Harnett County Department of Public Health

Improvement Permit

Construction Authorization

Harnett County Department of Public Health Site Sketch

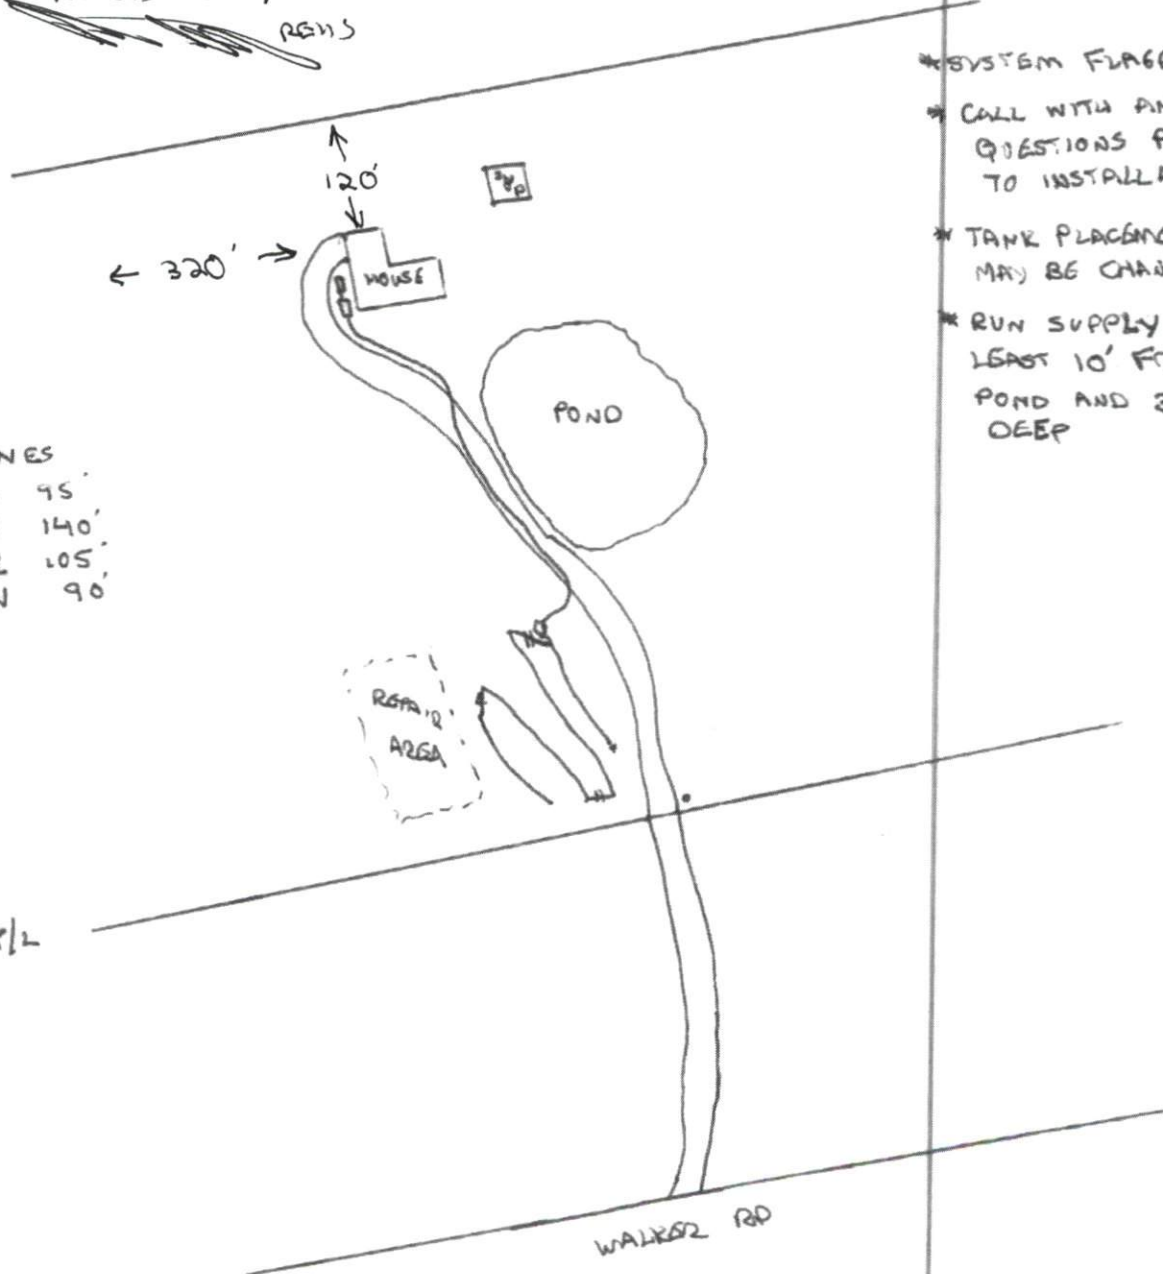
REVISED 11/23/21
 REMS

- LINES
- L R 95'
 - L L 140'
 - L R 105'
 - L L 90'

- * SYSTEM FLAGGED
- * CALL WITH ANY QUESTIONS PRIOR TO INSTALLATION
- * TANK PLACEMENT MAY BE CHANGED
- * RUN SUPPLY AT LEAST 10' FROM POND AND 30" DEEP
